Turkey Point

expansion project

Sufficiency Responses

Date: February 27, 2004
Project No.: 0337600-0105

SYSTEM	N/A	DISCIPLINE	CS	PLANT/UNIT	TURKEY POINT
SCALE	1"=200'	DWG FILE NAME	2FDEP-1.DWG	TITLE	EXPANSION PROJECT AERIAL DERIVED DEVELOPMENT PLAN
DRAWING SIZE	D(24"x36")	FPL FOLDER NAME	N/A		
DRAWING NUMBER	Figure 2FDEP-1			SHEET	1 OF 1
				REV	1

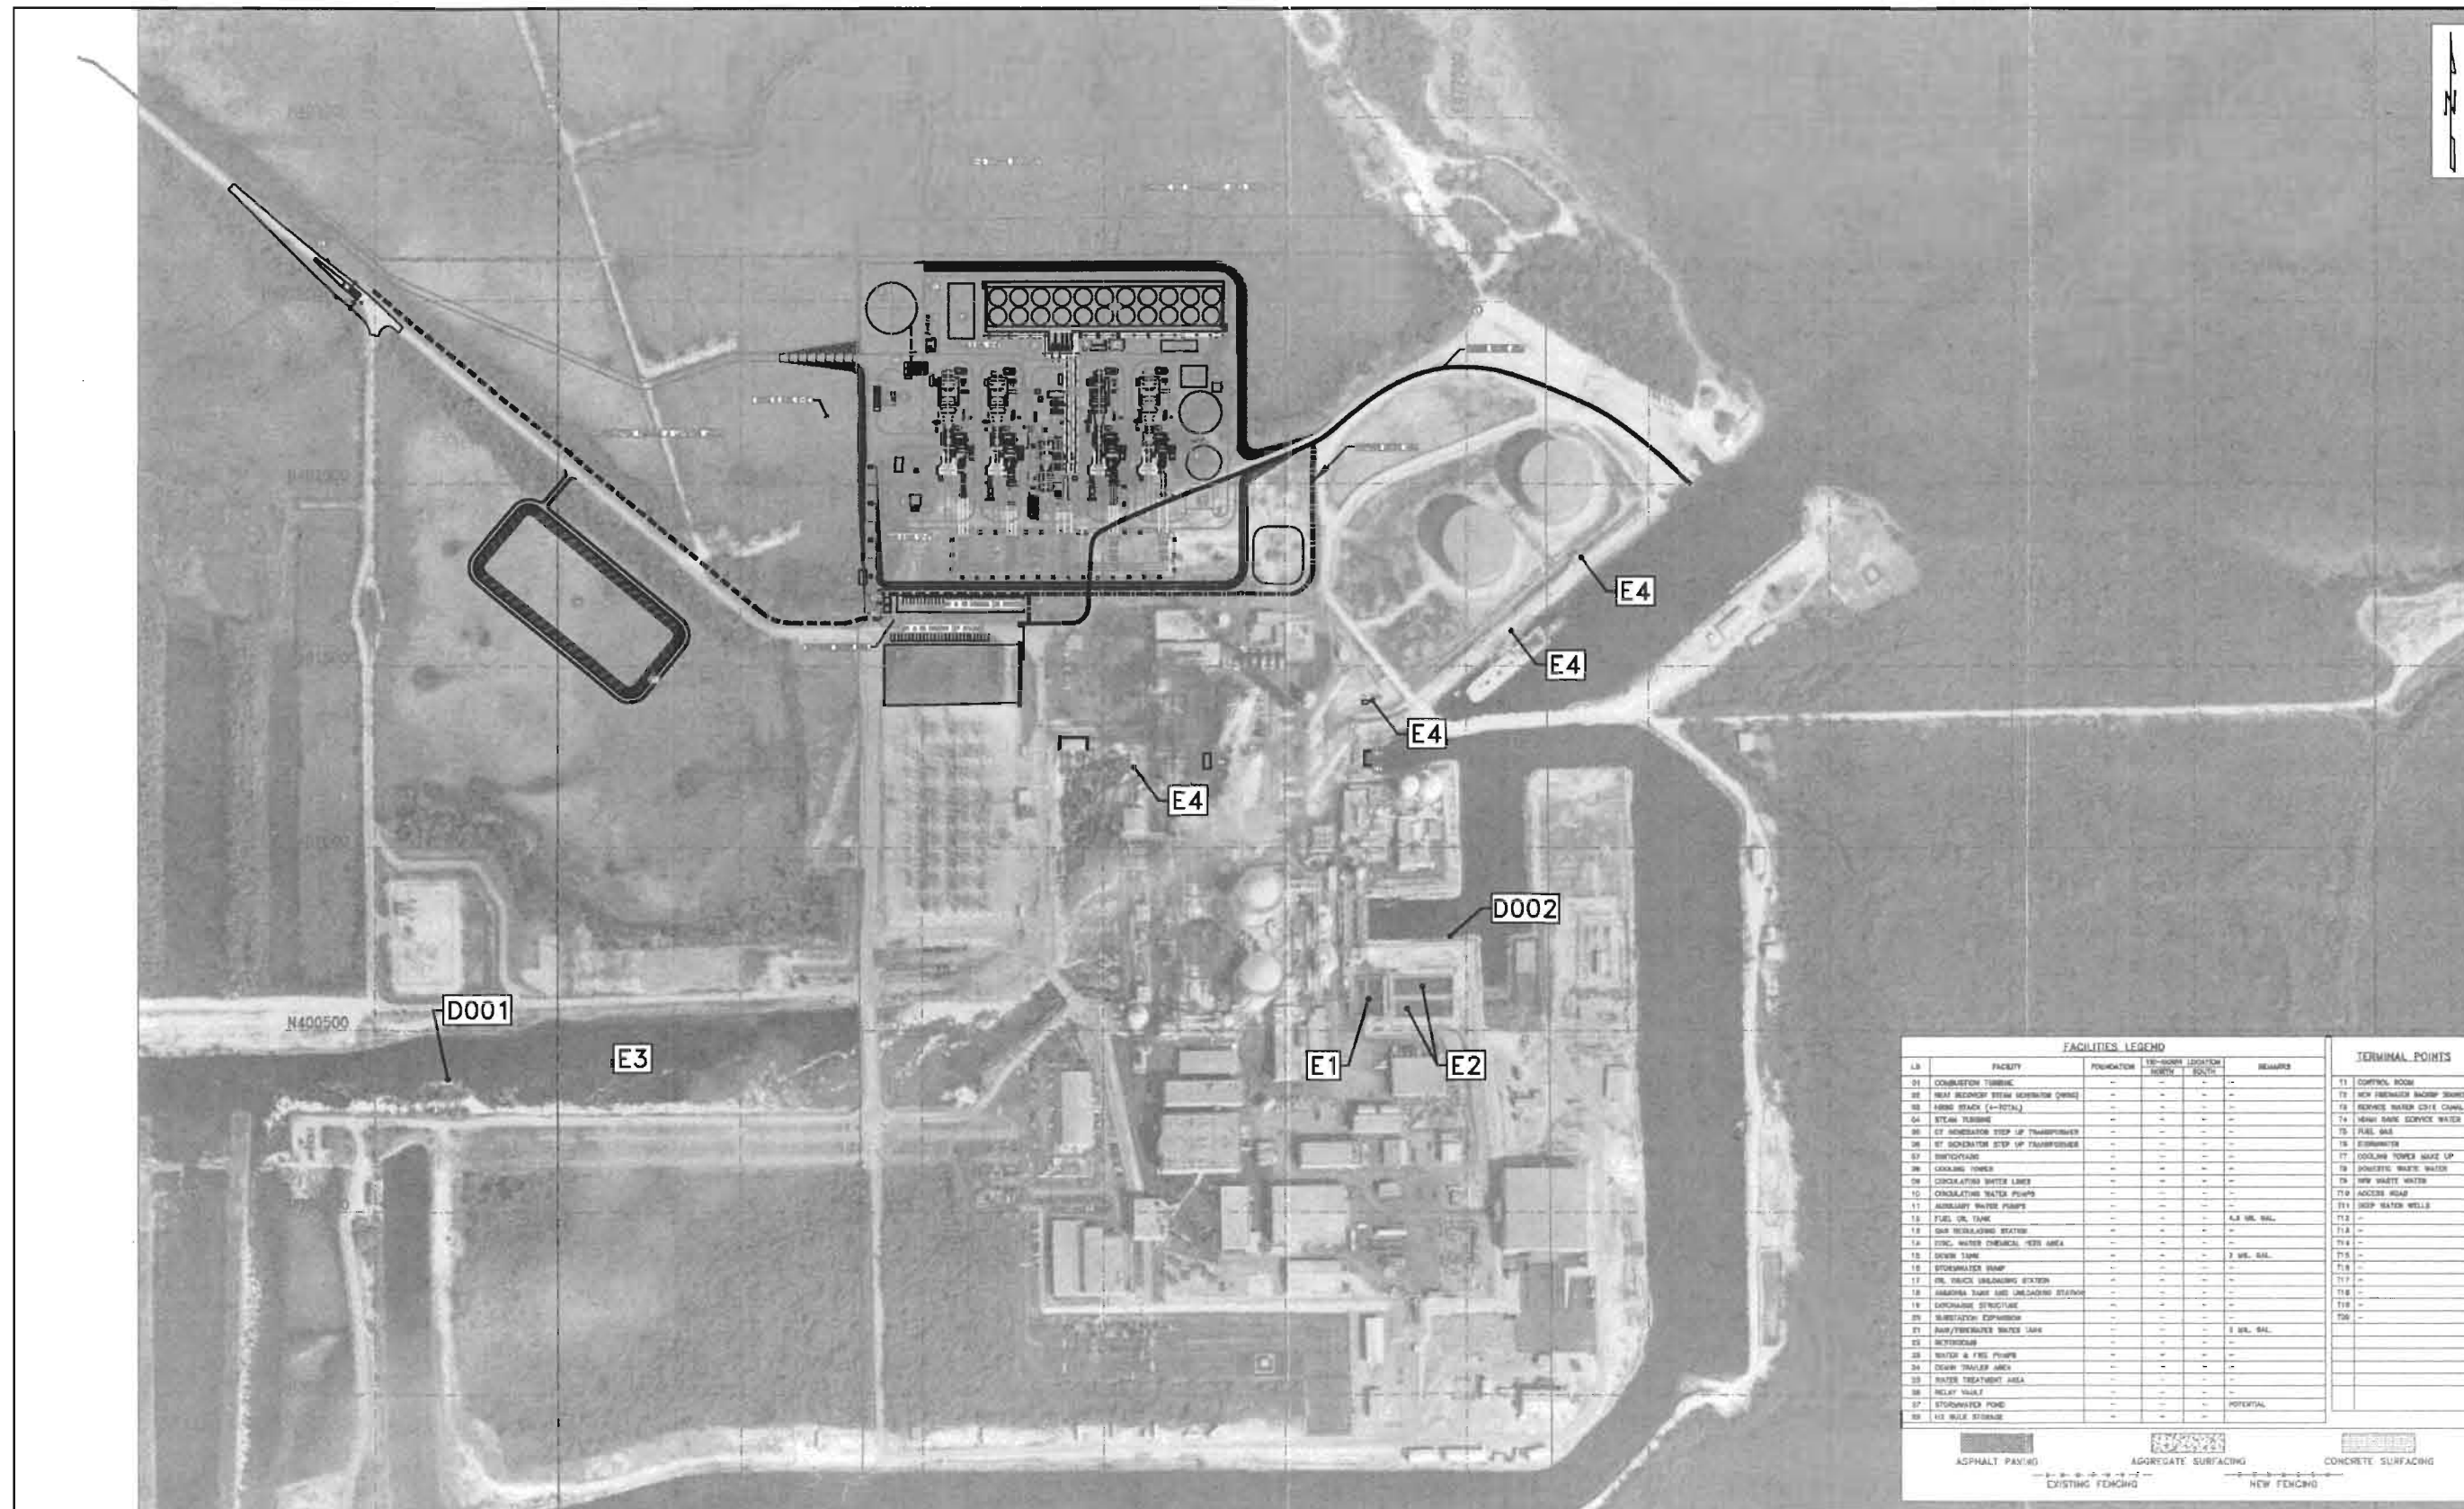
2FDEP Comment 1: Please submit a full-size copy of Figure 2.1-2. All the legends and other notations should be clearly legible and not overlapped. To facilitate Wastewater Permitting Section's review, the drawing should call out the locations for Lake Warren, its outfall structure, D-001, and the several oil/water separators, and wastewater treatment (neutralization) basin B-1, and solids settling basins B-2 and B-3, and their outfall structure, D-002.

Response: Attached is Figure 2FDEP-1 (11" by 17") that shows the Development Plan for the Turkey Point Expansion Project showing the following existing wastewater facilities: neutralization basin B1, solids settling basins B2 and B3, Lake Warren, oil/water separators and outfalls (DOO1 and OO2). These features are part of the existing Turkey Point Plant and permitted under Industrial Wastewater Facility Permit FL0001562 (See SCA Appendix 10.4). A full size copy of Figure 2FDEP-1 will be provided to the commenter.

Figure 2FDEP-2
Waste Flow Diagram

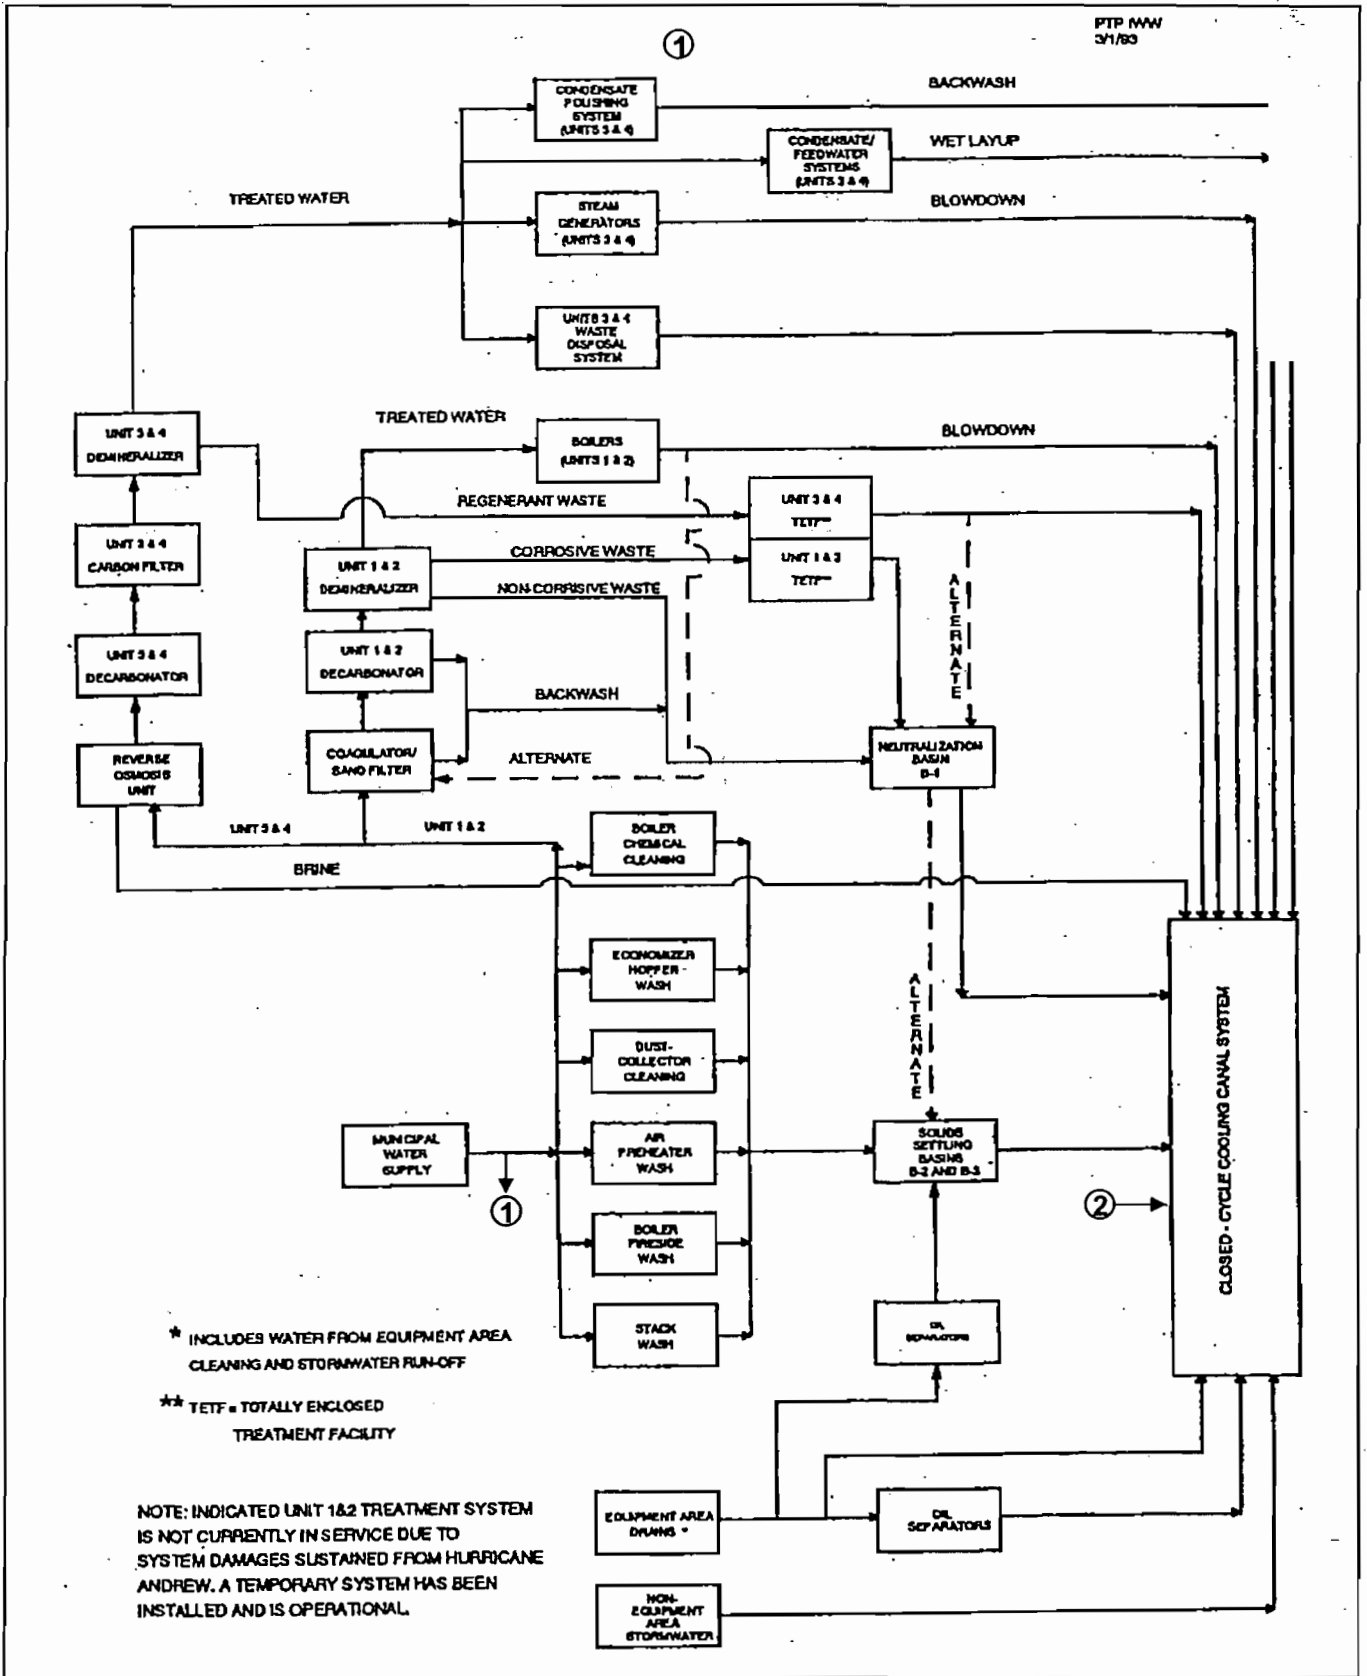
2FDEP Comment 2: Please expand and revise the flow schematic as presented in Figures 3.5-1 and 3.5-2, to distinct the process "waste water sump" into its existing individual components of neutralization basin B-1, and solids settling basins B-2 and B-3, and any other new treatment components being proposed under the expansion. (Attached here for sample is a file copy of the flow diagram for March 1, 1993, showing more details for the flow schemes.)

Response 2: Figures 3.5-1 and 3.5-2 have been updated and are attached as replacement pages. These figures were revised to identify the existing and new facilities and were updated to reflect the updated Cooling Pond Modeling Report contained in the SCA as Appendix 10.7 (see response to 2FDEP-4). Figure 2FDEP-2 identifies the connections on the previous waste flow diagram. The waste water sump shown on Figures 3.5-1 and 3.5-2 is a new facility that will serve Unit 5 only. The sump location is shown on Figure 3.2-2 as Item 16, designated "stormwater sump". Neutralization Basin B-1 and solids settling basins B-2 and B-3 serve existing Units 1-4 exclusively and are already permitted.

Figure 2FDEP-6a
Monitor Well Locations

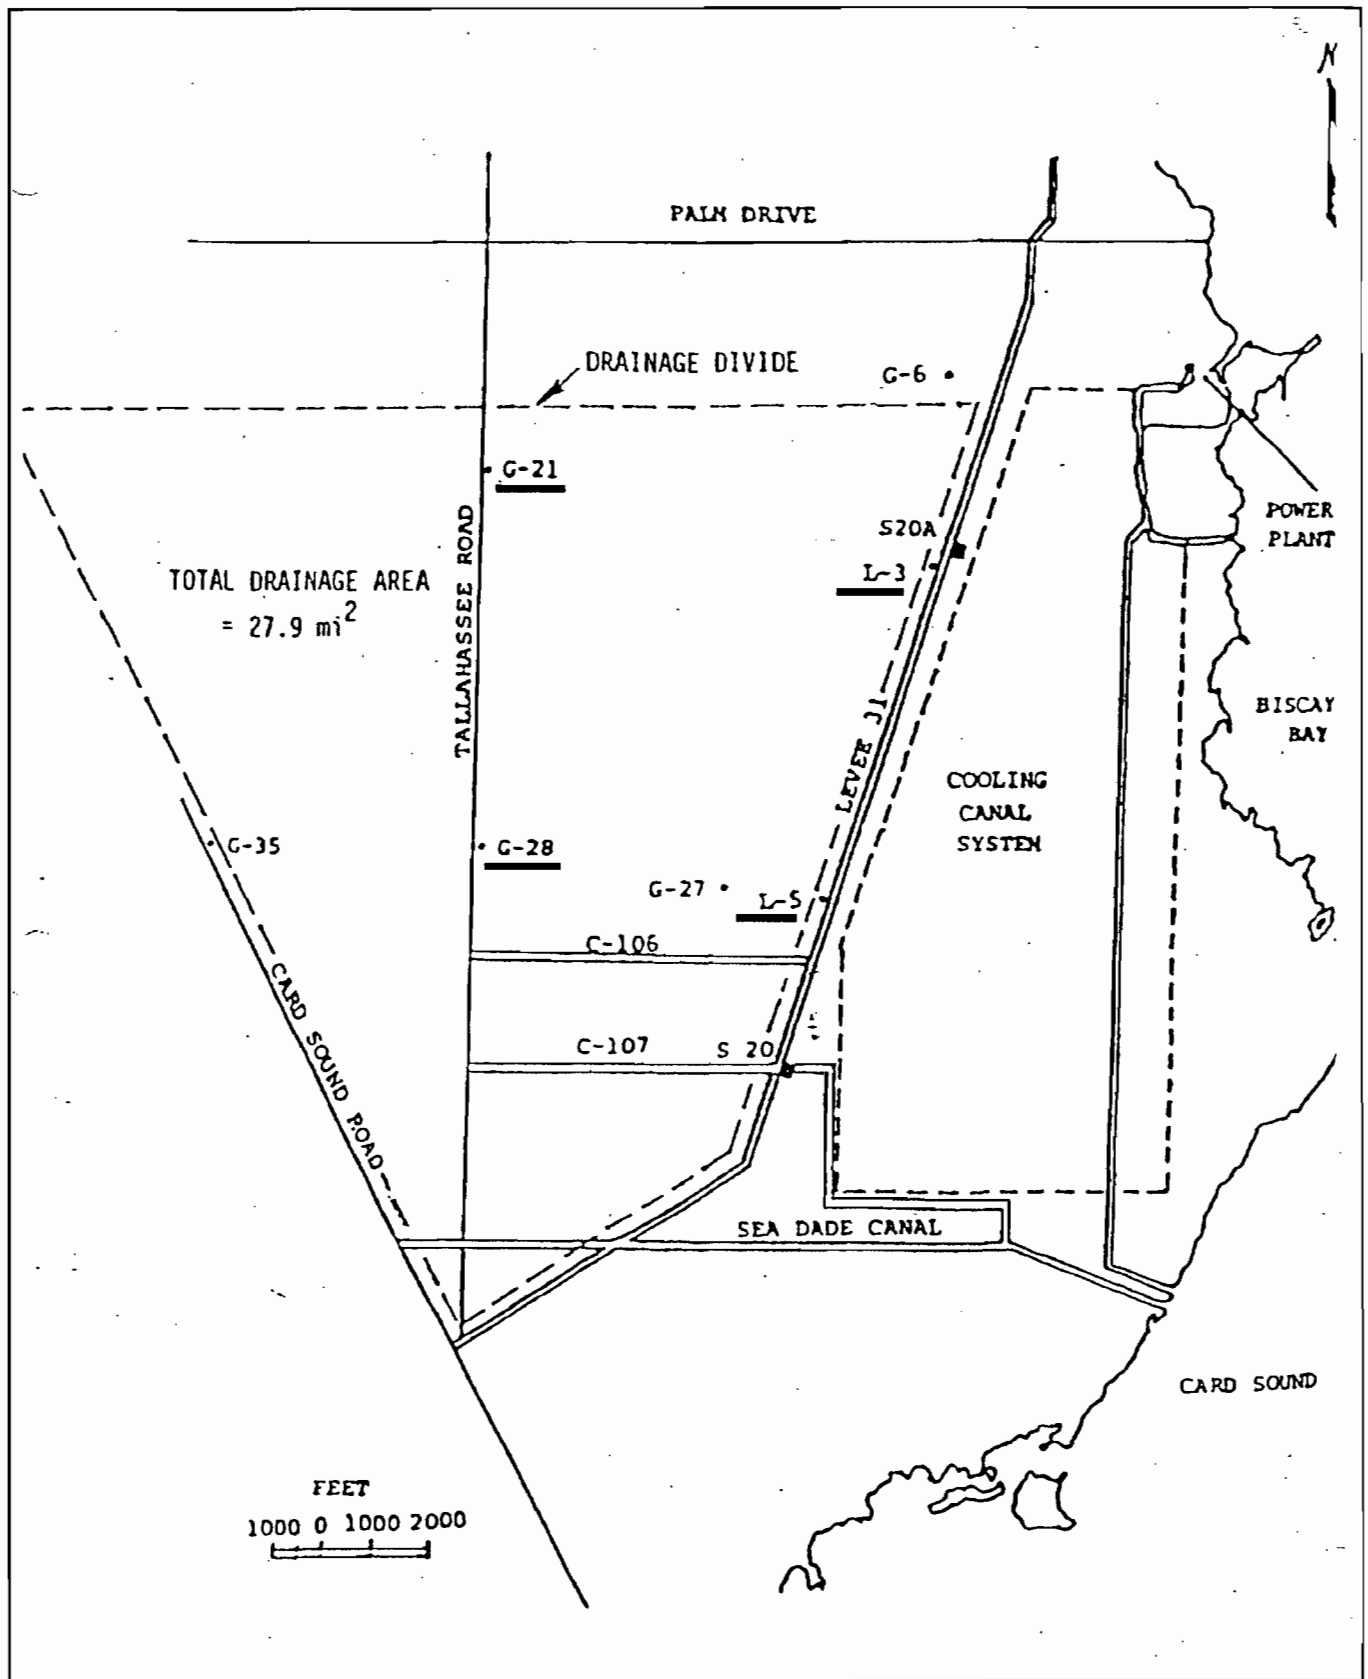
- (c) Please provide the depths and screened intervals for the six groundwater monitoring wells west of L 31E: L-3, L-5, G-6, G-21, G-27, G-28 and G-35, as referenced in SFWMD Agreement in Appendix 10.4. 2FDEP-7(c)

FPL and SFWMD are parties to an agreement (see SCA Appendix 10.4 for copy of agreement) by which FPL quarterly monitors water level, water temperature, and conductivity, and calculates chlorinity, at one-foot intervals over the entire depth (70 feet, the full depth of the Biscayne Aquifer at this location) of each of four monitoring wells (see Figure 2FDEP-6a). Two of these wells (L-3 and L-5) are just west of the L-31E canal. The other two monitoring wells (G-28 and G-21) are just east of Tallahassee Road. These wells are located west of the cooling canal system to monitor any landward movement of the saltwater wedge. Conclusions reached from analysis of the results of the monitoring program, which has been ongoing since 1972, are:
